- 1. The Lincolnshire County Council (A15 Lincoln Eastern Bypass)  
(Classified Road) (Side Roads) Order 2014**
- 2. The Lincolnshire County Council (A15 Lincoln Eastern Bypass)  
Compulsory Purchase Order 2014**
- 3. Application In Relation To Proposed Compulsory Purchase Of  
Land Held By The Canal & River Trust**

**Department for Transport Reference: NATTRAN/EM/LAO/0084**

**Response to Objector's Proof**

**OBJ/472/1**

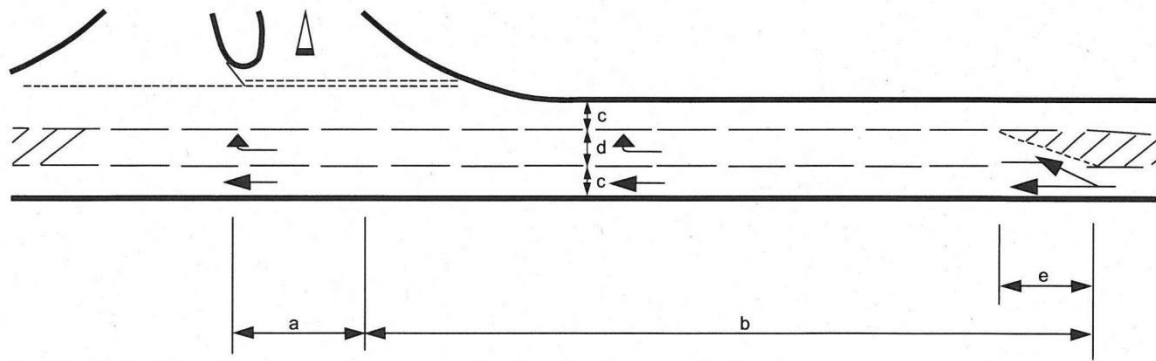
**2.2.1 Response:** Mr Lake is incorrect in that both the alternative designs fail to comply with the DMRB in the following areas:

**2.2.2** Bridge deck clearance over the LEB shown as 5.43 metres, this should be 6.45 metres as the LEB is currently designed as a high load route in accordance with TD 27/05. It appears that Mr Lake was not aware that the LEB was to be used as a high load route.

**2.2.3** Carriageway widths of the LEB under the proposed alternative are 3.65 metres and do not include hard strips nor allow sufficient lateral clearance for vehicles to pass breakdowns.

**2.2.4** In addition Mr Lake's proposal does not adopt the strategy of the proposed LEB as it does not appear to utilise the north bound carriageway of the dual scheme for the single carriageway scheme.

**Figure 7/8 : Ghost Island Development and Taper (para 7.30)**

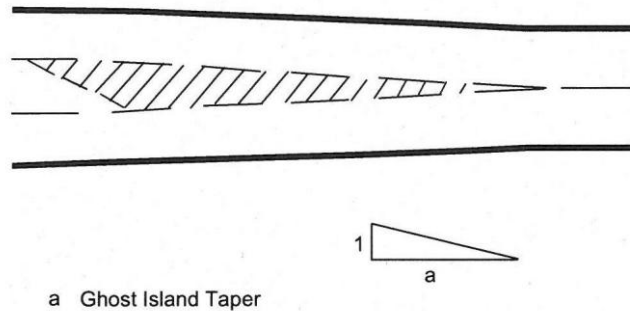
**2.3.1 Response:** Mr Lake is incorrect in that the design as shown does not comply with the 40 mph design speed (which as noted earlier would not be supported or used in any event by LCC or LRSP for this location), as described the tapers are too short being 15 metres instead of 57 metres assuming asymmetric widening. The tapers should however, be 71.25 metres for the required 50 mph design speed of the route. The correct combined taper, deceleration and turning lengths would impact on the bridge in Alternative 2 which would need to be widened in order to accommodate the additional carriageway width. Below are extracts from TD42/95: Figures 7/4, Paragraph 7.32 table 7/5a define turning and deceleration lengths, Figure 7/8 and Table 7/3 define Ghost Island tapers.
